Verification of MELCOR Input Decks Used in ITER RPrS Analyses

INL/EXT-07-13305

This report as part of an ITER Task Agreement, documents the verification of the MELCOR Input Computer Decks used in performing the required safety analyses to be presented in the Preliminary Safety Report (Rapport Préliminaire de Sécurité, RPrS).

Figure 5-4 Divertor Heat Transport Model in Large Divertor Ex-Vessel Pipe Break Deck

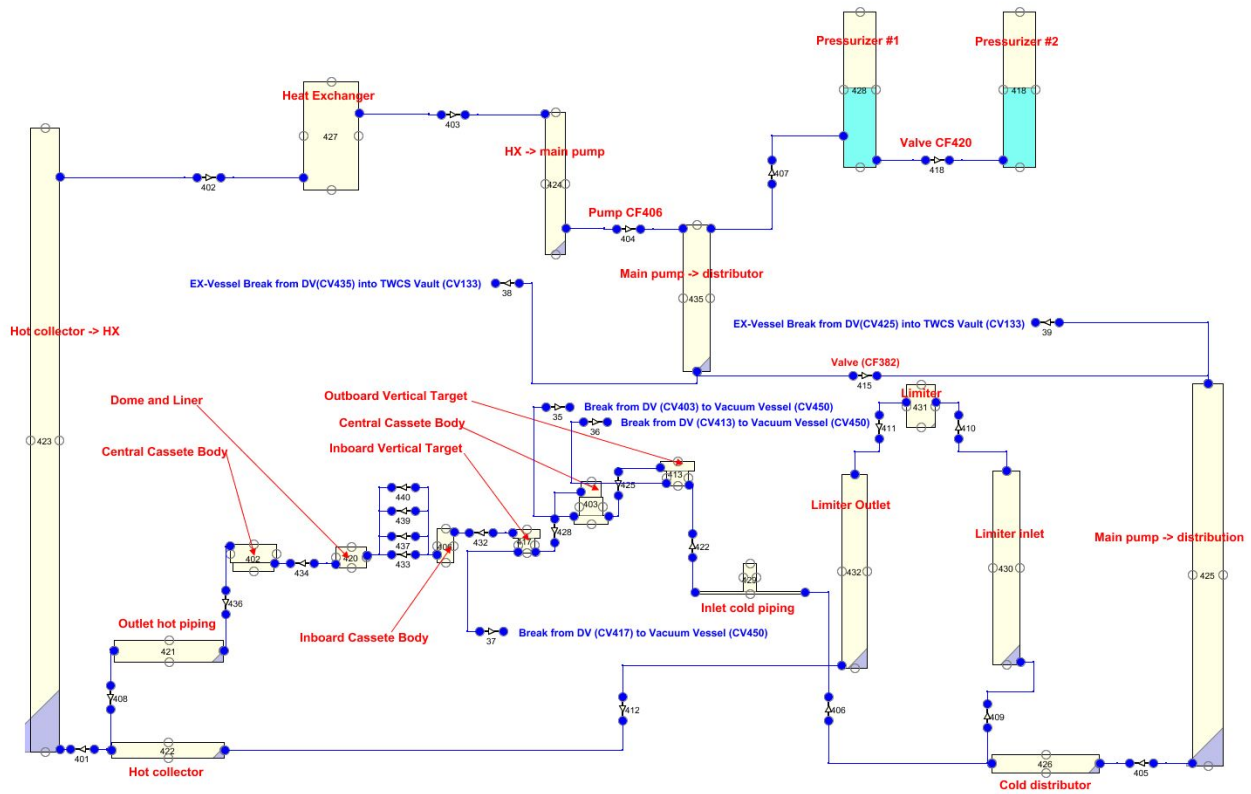
- 1) The hydraulic diameter of FP 418 (Figure 5.4) was found to be incorrect in the original deck. It was changed from 0.127 m to 0.87 m which corresponds to the one loop hydraulic diameter value between pressurizer #1 (CV428) and pressurizer #2 (CV418).

Figure 6-1 FW/BLK Model (one intact loop) in Loss of Vacuum Dry-Bypass Deck

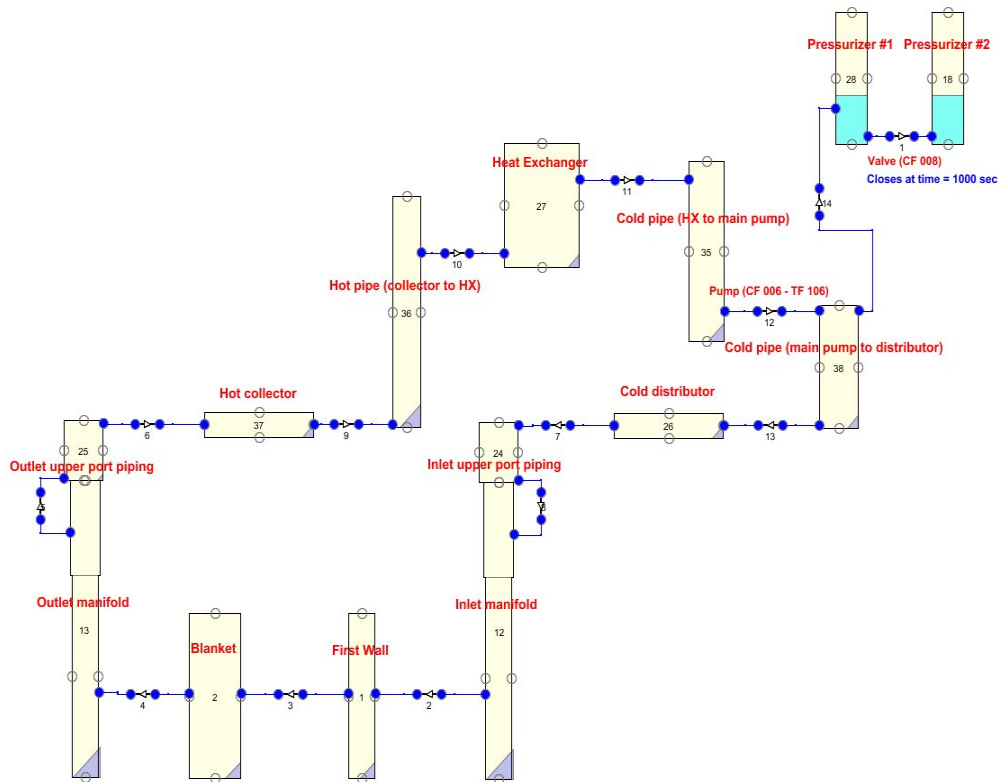
- 1) The flow area of FP 1 (Figure 6.1) was found to be incorrect in the original deck. It was changed from 1.18 m² to 0.59 m² which is the flow area corresponding to one FW/BLK coolant loop [Topilski07]. The hydraulic diameter was also changed from 0.122 m to 0.87 m which corresponds to the one loop flow area (0.59 m²) between pressurizer #1 (CV028) and pressurizer #2 (CV018).

- 2) The lengths of FP fl006s2, fl007s1, fl009s1, fl013s2 (Figure 6.1) and FP fl906s2, fl907s1, fl909s1, fl913s2 (Figure 6.2) were determined to be incorrect in the original deck. Their lengths were decreased from 66 m to 33 m. Because of the reduction in lengths, the total length of fl006, fl007, fl009, fl013, fl907, fl907, fl909, and fl913 are 45.3m, 45.3 m, 46.2 m, 49.1 m, 45.3 m, 45.3 m, 46.2 m, 49.1 m respectively [Topilski07].

Figure 6-2 FW/BLK Model (two intact loops) in Loss of Vacuum Dry-Bypass Deck

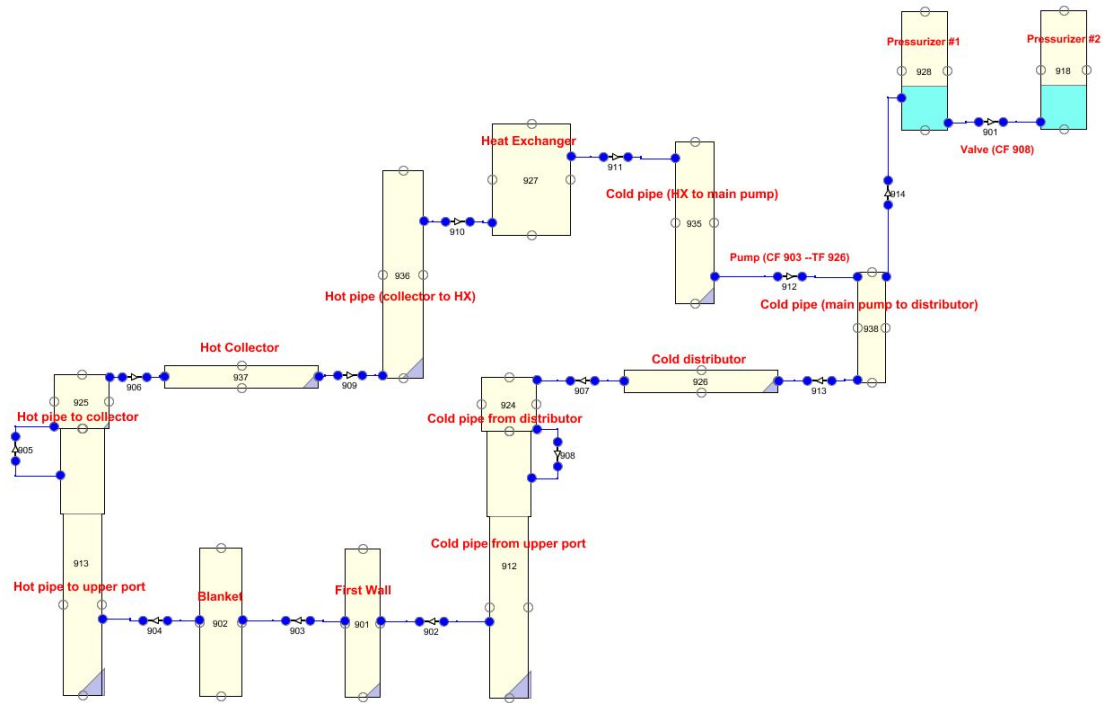
- 4) The hydraulic diameter of FP 901 (Figure 6.2) was determined to be incorrect in the original deck. It was changed from 0.122 m to 0.87 m.
- 5) CF906 (control function 906) which controls when the FW/BLK heat exchanger for the two FW/BLK intact coolant loops is turned off was changed from 1.32E+05 second to 1.0E+06 seconds. However, there was no criterion identified in the [AAS07] for determining when the HX should be shut off.

Figure 7-1 FW/BLK Model (three failed loops) in Multiple FW Pipe Break Deck

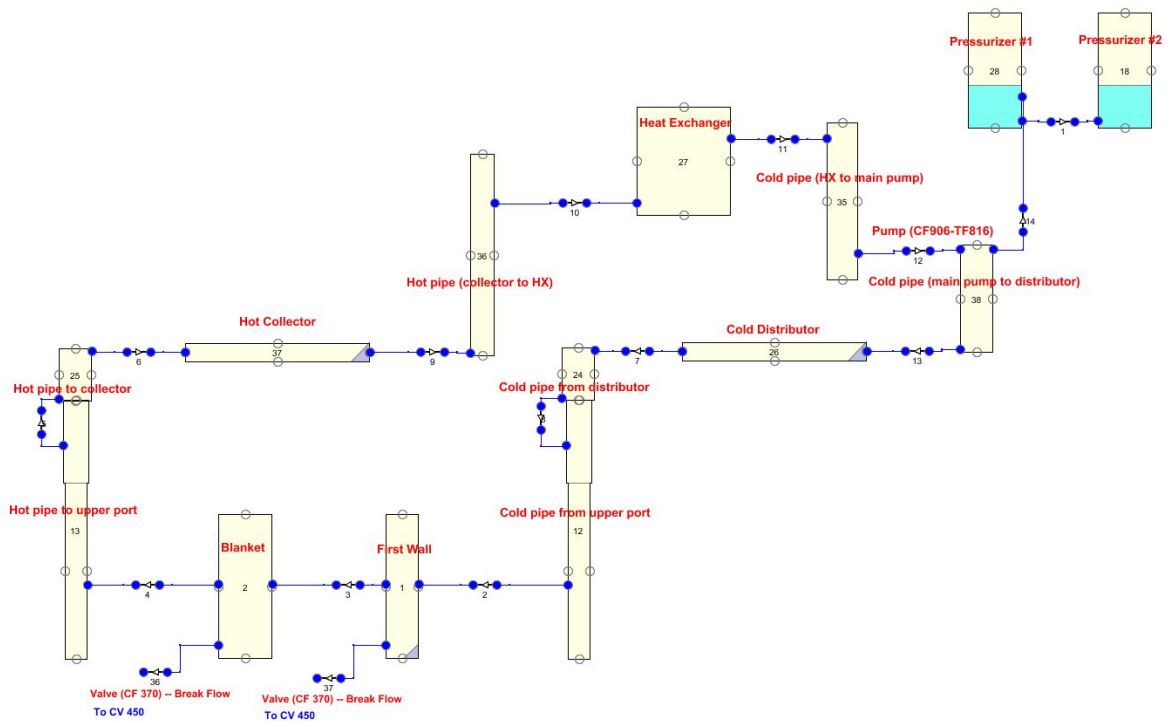
- 1) The hydraulic diameter of FP 1 (Figure 7.1) was determined to be incorrect in the original deck. It was changed from 0.127 m to 0.87 m in the 11/27/07 deck.

- 2) The lengths of FP fl006s2, fl007s1, fl009s1, and fl013s2 (Figure 7.1) were determined to be incorrect in the original deck. Their lengths were decreased from 66 m to 33 m. Because of the reduction in lengths, the total length of fl006, fl007, fl009, and fl013, are 45.3m, 45.3 m, 46.2 m, 49.1 m respectively [Topilski07].

Figure 7-3 Confinement and Vent-Detrition Model in Multiple FW Pipe Break Deck

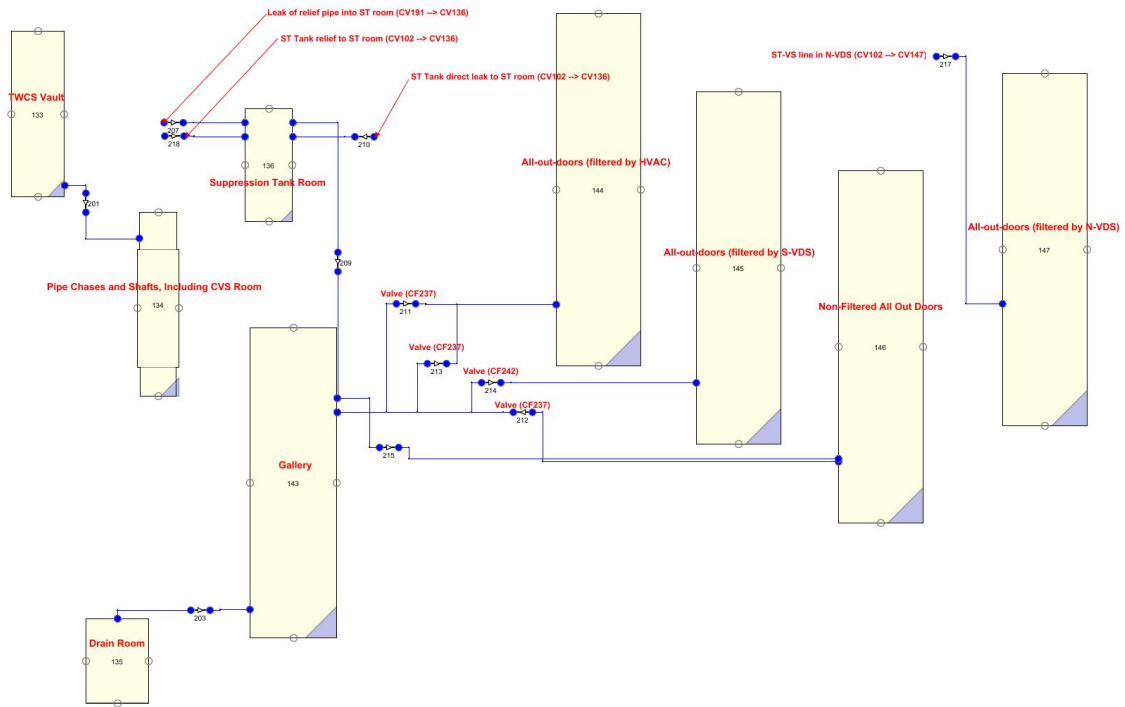
- 3) See item 13 – section 2.
- 4) See item 14 – section 2.
- 5) The volume of the Gallery (CV143 – Figure 7.3) in the original deck did not agree with the value listed in [SADL07]. The volume in the latest deck was changed from 66000 m³ to 72000 m³ to agree with the data in [SADL07].

Figure 8-1 FW/BLK Model (failed loop) in VV Cryostat Failure Water Air Ingress Deck

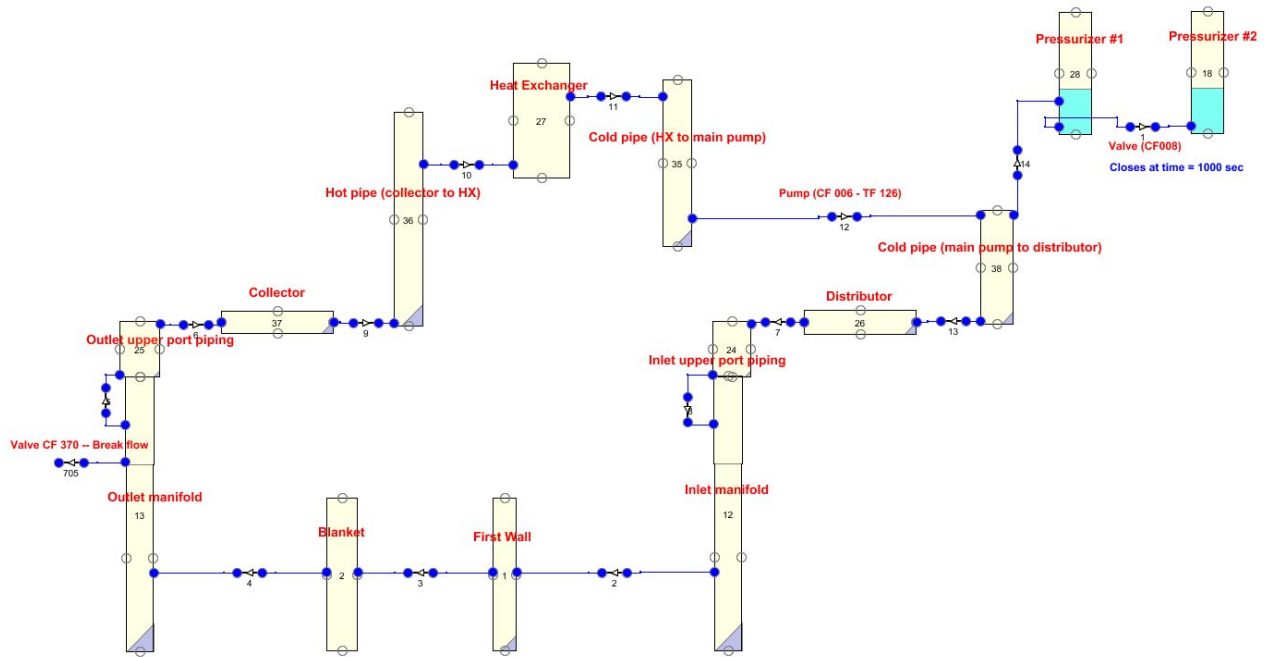
- 1) The hydraulic diameter of FP 001 (Figure 8.1) was determined to be incorrect in the original deck. It was changed from 0.122 m to 0.87 m.
- 2) See item 4 – section 5.
